# PIC24FJ64GB004 FAMILY

## PIC24FJ64GB004 Family Silicon Errata and Data Sheet Clarification

The PIC24FJ64GB004 family devices that you have received conform functionally to the current Device Data Sheet (DS39940D), except for the anomalies described in this document.

**FIGURE 2-3 FREQUENCY vs. ESR PERFORMANCE FOR SUGGESTED VCAP**

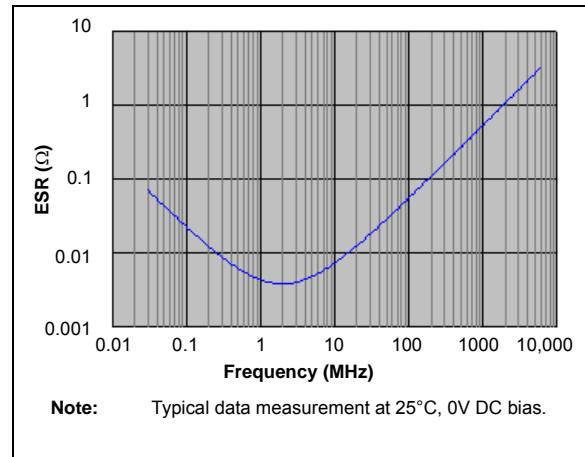
**Section 2.4 Voltage Regulator Pins (ENVREG/DISVREG and VCAP/VDDCORE)** has been replaced with a new and more detailed section. The entire text follows:

When the regulator is enabled, a low-ESR ( $< 5\Omega$ ) capacitor is required on the VCAP/VDDCORE pin to stabilize the voltage regulator output voltage. The VCAP/VDDCORE pin must not be connected to VDD and must use a capacitor of 10  $\mu\text{F}$  connected to ground. The type can be ceramic or tantalum. Suitable examples of capacitors are shown in [Table 2-1](#). Capacitors with equivalent specifications can be used.

Designers may use [Figure 2-3](#) to evaluate ESR equivalence of candidate devices.

The placement of this capacitor should be close to VCAP/VDDCORE. It is recommended that the trace length not exceed 0.25 inch (6 mm). Refer to **Section 29.0 “Electrical Characteristics”** for additional information.

**FIGURE 2-4 DC BIAS VOLTAGE vs. CAPACITANCE CHARACTERISTICS**

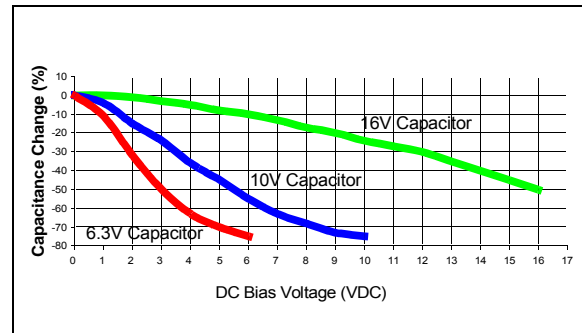
In addition to temperature tolerance, the effective capacitance of large value ceramic capacitors can vary substantially, based on the amount of DC voltage applied to the capacitor. This effect can be very significant, but is often overlooked or is not always documented.

A typical DC bias voltage vs. capacitance graph for 16V, 10V and 6.3V rated capacitors is shown in Figure 2-4.

When selecting a ceramic capacitor to be used with the internal voltage regulator, it is suggested to select a high-voltage rating, so that the operating voltage is a small percentage of the maximum rated capacitor voltage. For example, choose a ceramic capacitor rated at 16V for the 2.5V core voltage. Suggested capacitors are shown in Table 2-1.
